MRI Replacement
Misc. Suite Alterations
1400 S. Potomac Street, Suite 180
Aurora , CO 80012

City of Aurora Building Division
Project: *Tenant Improvement*
Address: *1400 S Potomac St, Unit 180*
Occupancy Group: *B*
Construction Type: *UBC IIN-Spk*
RSN: *1281167*
Permit: *18-1445333-LT*

City of Aurora Building Division
Reviewed for Code Compliance
Approved as Noted: jlocke
Date: May 01, 2018
2015 INTERNATIONAL CODES & 2017 NEC

4 Level 1 - Egress Plan
3/32" = 1'-0"

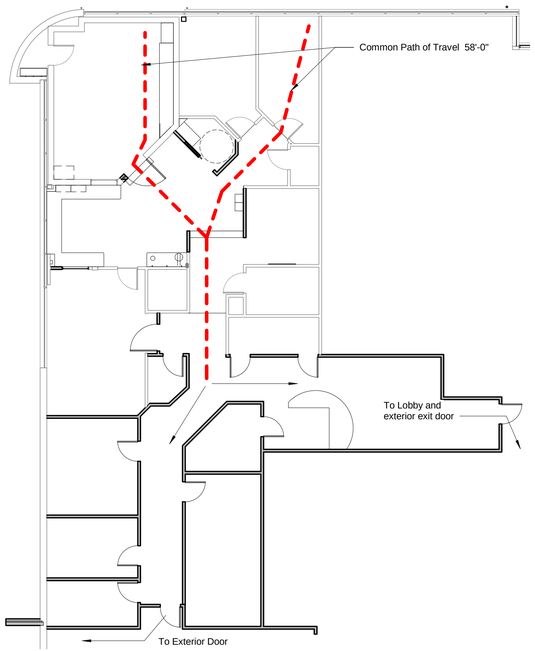
MEANS OF EGRESS
Chapter 10
- **No change to existing egress route or common path of travel**
- **3,700 s.f tenant space (Group B) / 100 = 37 people;**
- **Occupant load < 49; one exit required (Table 1015.1)**
- **Maximum Common Path of Egress travel: 100' (sprinkled - IBC Table1014.3; occupant load > 30**
- **Maximum Travel Distance: 300' at B (fully sprinkled - Table1016.2)**
- **Occupant load < 50 therefore exit door do not have to swing in the direction of travel (IBC 1008.1.2)**

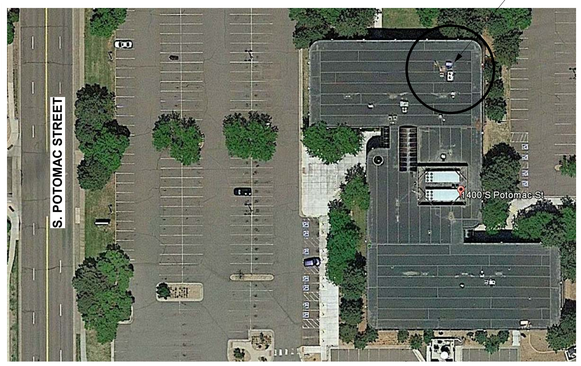
SEPARATE FIRE SPRINKLER PERMIT REQUIRED: Due to the proposed work the general contractor is required to obtain the services of a fire sprinkler contractor to determine if a separate sprinkler permit is required. If it is determined that the spacing of the fire sprinkler heads is not in compliance, then a separate fire sprinkler permit is required. Approval of the documents is required prior to system installation or any request for inspection. A certificate of occupancy or final approval cannot be issued by the Building Division without this fire protection system. **2015 IFC, Section 105.7.1.**

2 PARTIAL ONE-LINE DIAGRAM

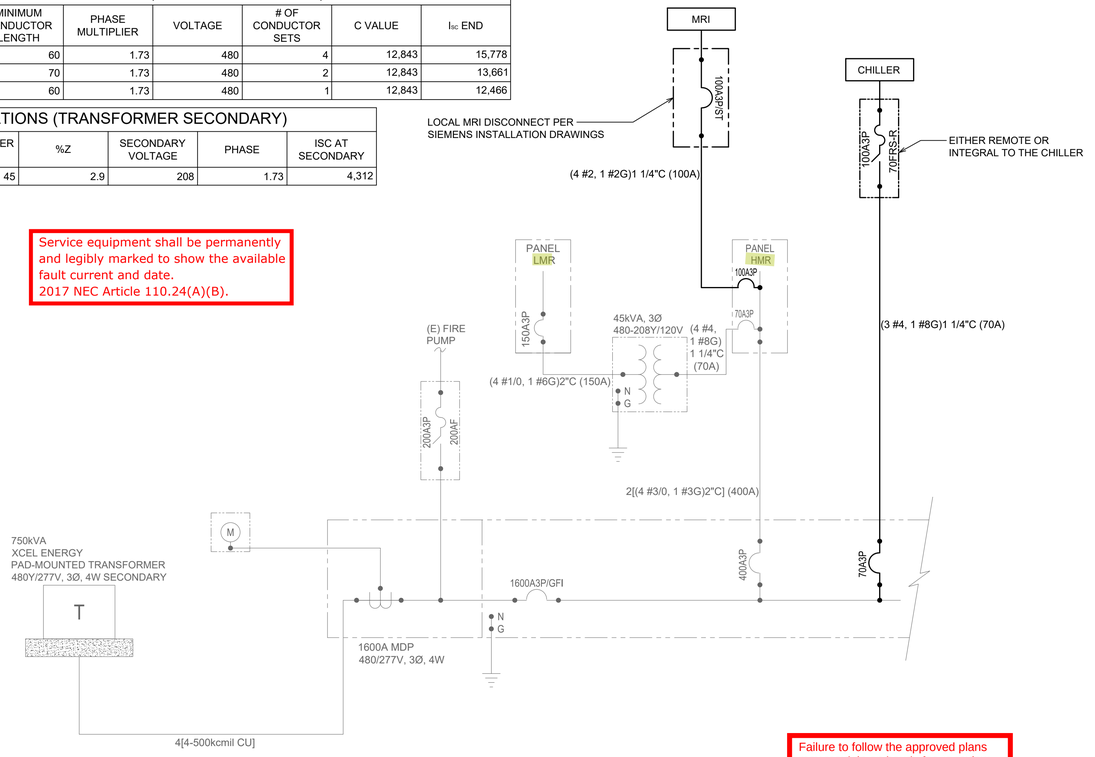
Service equipment shall be permanently and legibly marked to show the available fault current and date.
2017 NEC Article 110.24(A)(B).

Legibly identify each breaker or switch for it's use or purpose on the circuit directory in the panel/switchboard per 2017 NEC 408.4.

1 PARTIAL POWER PLAN
SCALE: 1/4" = 1'-0"

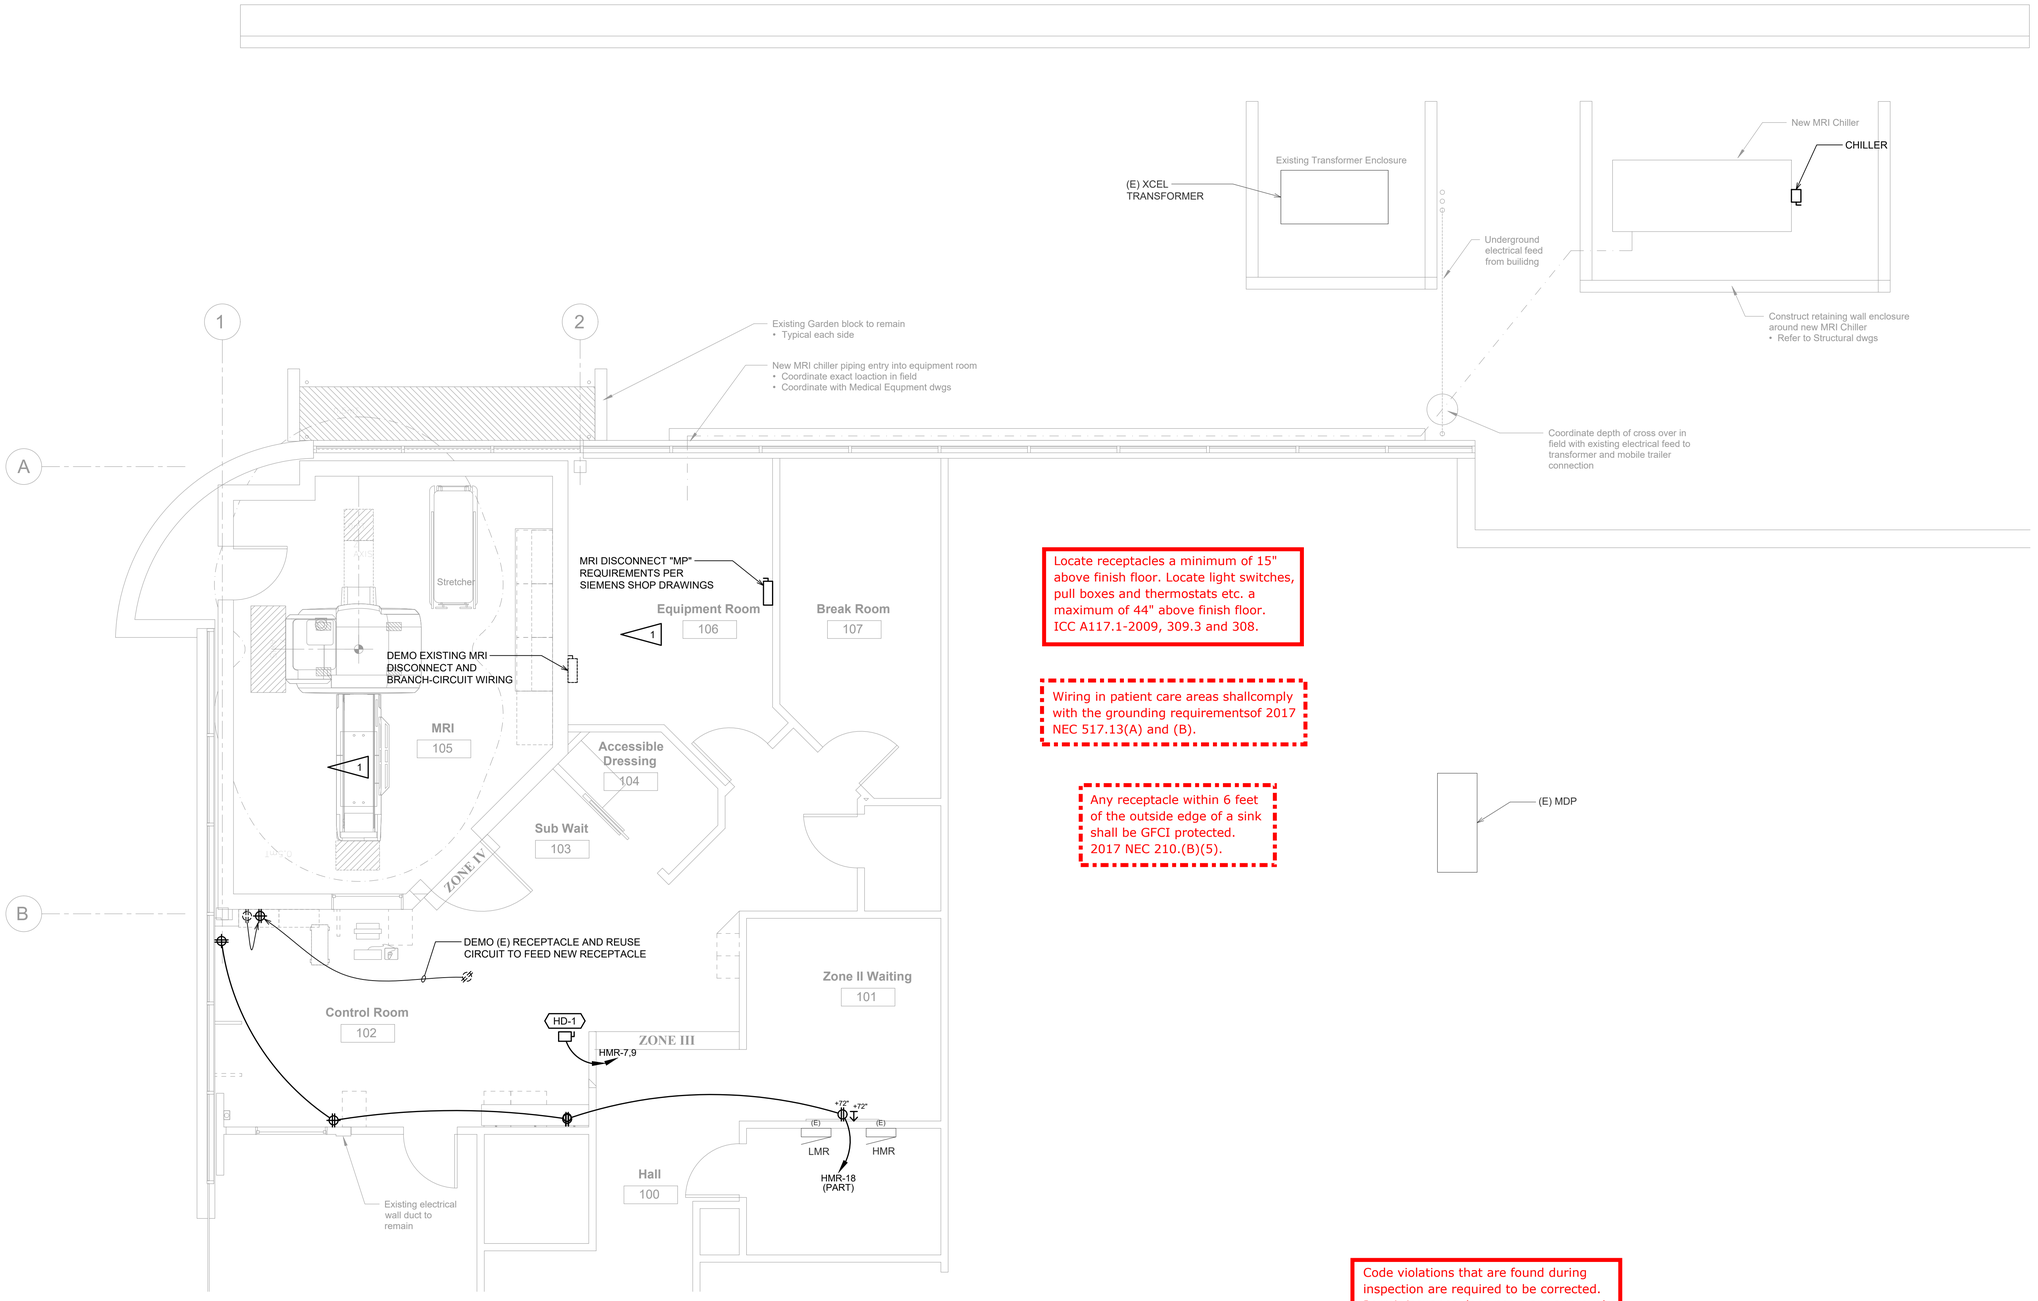
Locate receptacles a minimum of 15" above finish floor. Locate light switches, pull boxes and thermostats etc. a maximum of 44" above finish floor. ICC A117.1-2009, 309.3 and 308.
